SUNDRY NOTICES AND REPORTS ON WELLS
Do not use this form for proposals to drill or to re-enter an abandoned well. Use Form 3160-3 (APD) for such proposals.

8 Well Name and No
SKELLY UNIT #939

SKELLY UNIT #939 DEEPENING PROGRAM

Skelly Unit 939
Chevron USA Inc.
30-015-32598
June 9, 2010
Conditions of Approval

Centralizer Diagram

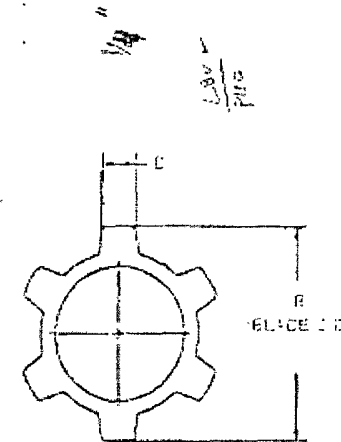
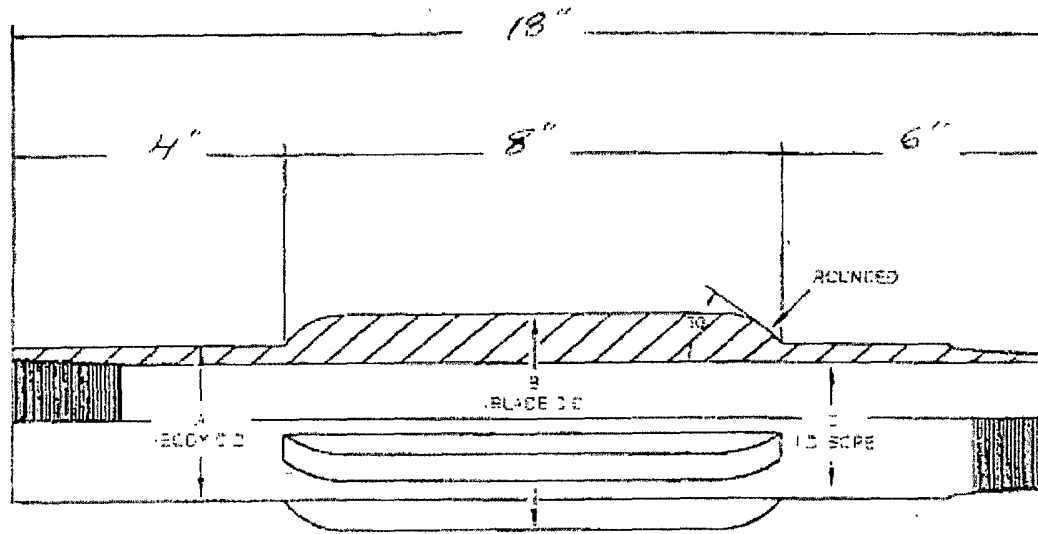
Fixed blade stabilizer subs will be utilized in the casing string to insure adequate isolation and seal throughout the wellbore. These stabilizer subs are positive fixed blade type. These subs will actually be screwed into the casing string. A diagram of the fixed blade stabilizer sub is located at the end of this program.
